URBAN PLANNING PARTNERS INC.

MEMORANDUM

RE: CEQA Compliance for MacArthur BART Transit Village Stage[1] 2 FDP

RE: Response to Letters Received Regarding the MacArthur Transit Village Stage One Final Development Plan Permit and Vesting Tentative Track Map 8047.

Exhibit A-1 Project Site Area and Surgery Center Location

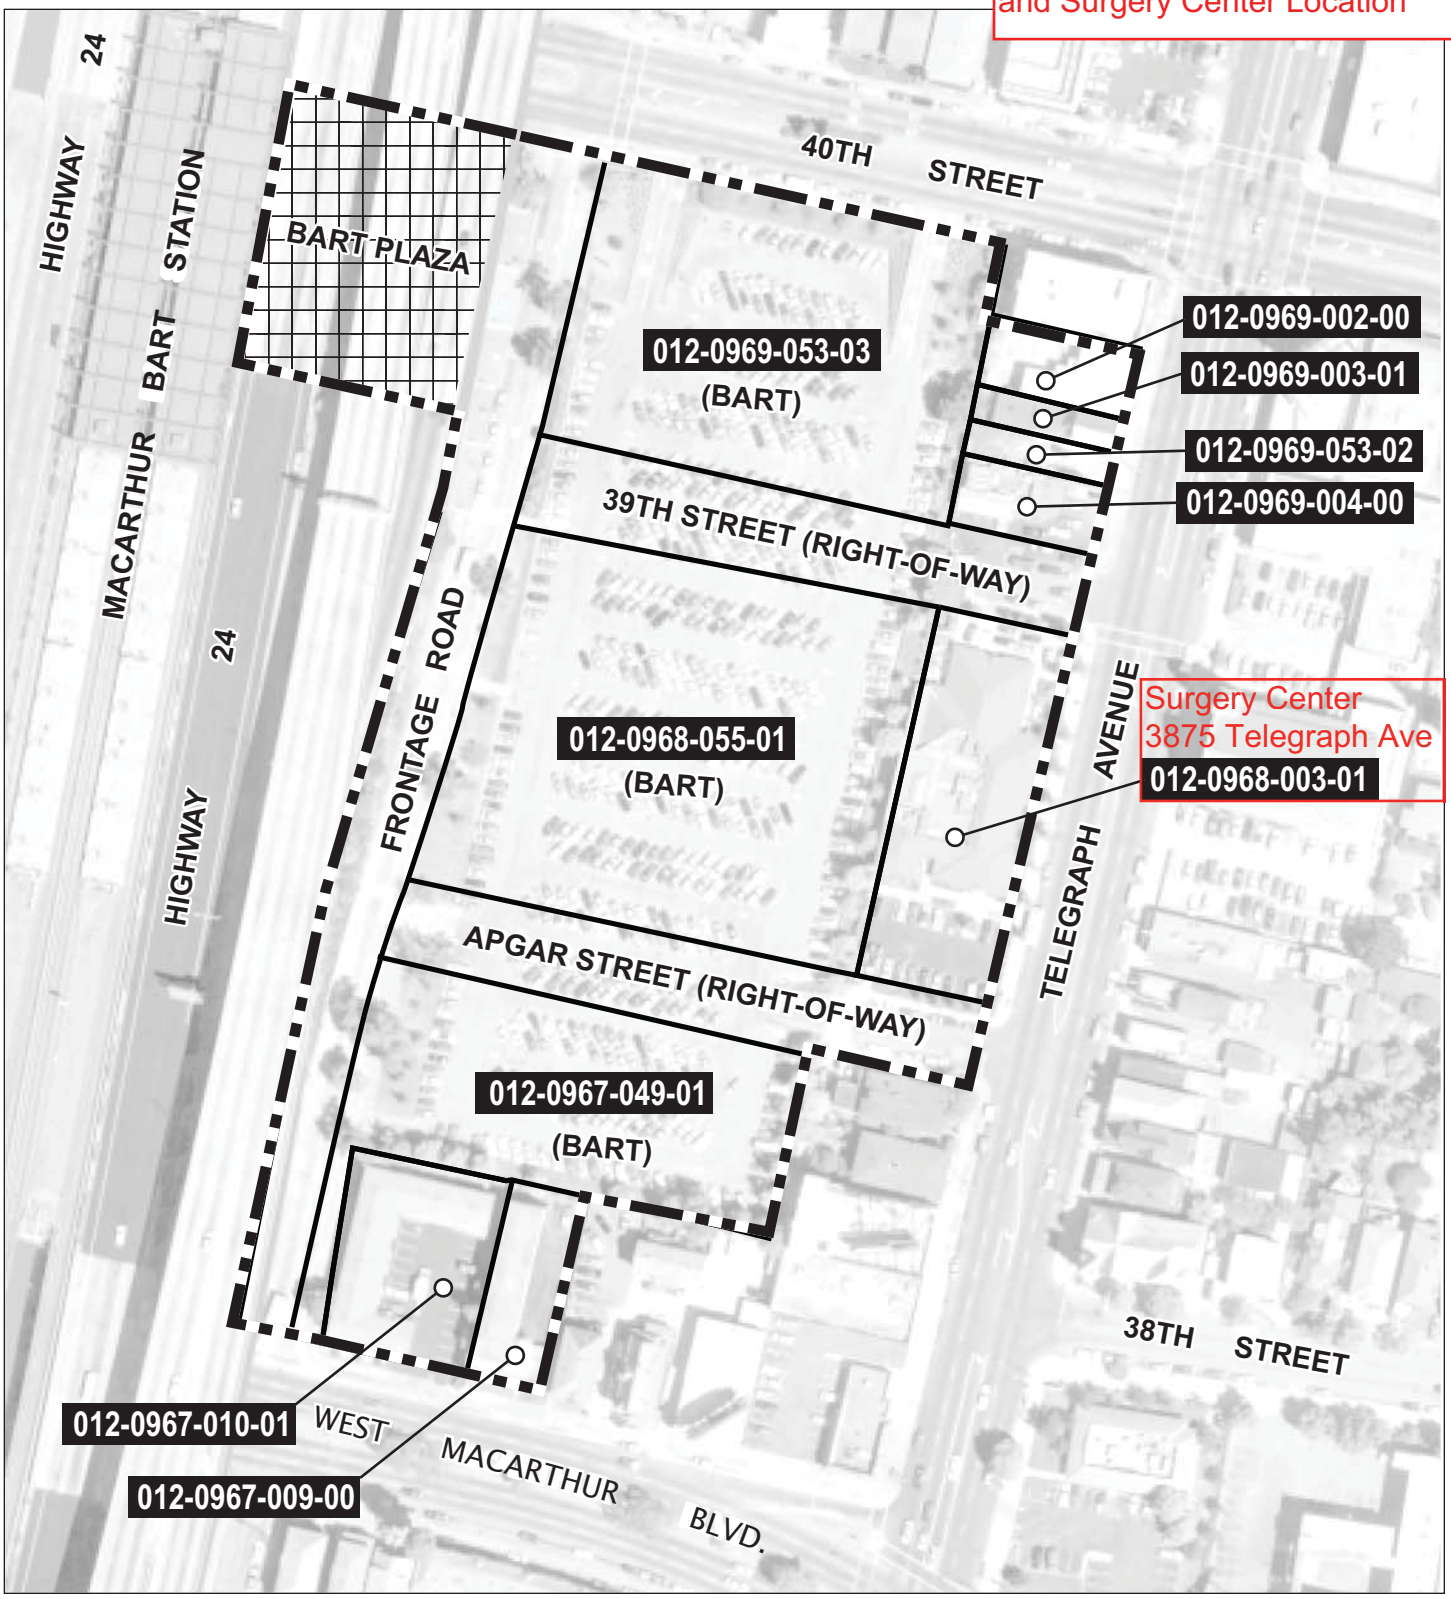
The Surgery Center asserts that the MTV Project has been changed to delete the Surgery Center site. Additionally, the Surgery Center asserts that the Staff Report contains inconsistent project descriptions.

The Surgery Center letter states that the City Staff Report contains an inconsistent Project description. This comment misinterprets the Staff Report. The Surgery Center's assessor parcel number is listed as part of the overall MTV Project site approved in the PUD (and other MTV Project approvals) and the parcel is shown as part of the MTV Project site on the zoning map included in the Staff Report. This information confirms that the Surgery Center parcel remains a part of the MTV Project, even though it is not included in the Phase/Stage 1 FDP and the VTTM.

Response 1. The MTV Project has not changed to exclude the Surgery Center parcel. The MTV Project has always been proposed, analyzed in the 2008 EIR, and approved as a phased project. The Phase/Stage 1 FDP under consideration by the City Council simply represents the first phase of the MTV Project. The 2008 EIR, the MTV PUD, and the MTV Development Agreement all describe a phased project and establish requirements related to the phased final applications. The Surgery Center parcel is located in block C of the MTV Project site (see Exhibit A). The development on block C is designated as Phase 5 and the final applications for block C are not expected to be pursued for several years. Consequently, there is no reason or requirement to include the development proposed for the Surgery Center parcel in the Phase/Stage 1 FDP application.
